Ogg.: "HD 900" FRIGGITRICI, SOSTITUZIONE LIMITATORI DI TEMPERATURA.

Obj.: "HD 900" FRYERS, SAFETY THERMOSTATS REPLACEMENT.

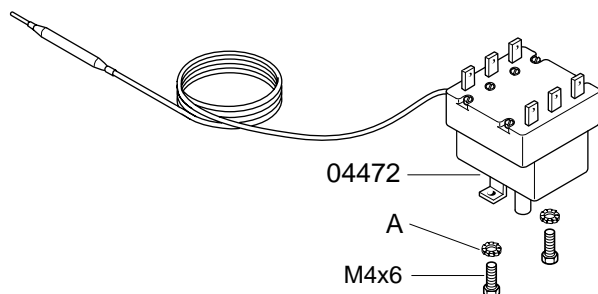
ELECTRIC-HEATED FRYERS - From serial number 901..... onwards, the old thermostat 59559 has been replaced by the new code 04472.

The new part is interchangeable with the old one by using two "M4x6" screws with toothed washers (see reference "A" in the picture here below) and connecting the electric wires as described in the table underneath.

Rif. cavo Ref. cable	Rif. limitatore Ref. thermostat
1	11
2	12
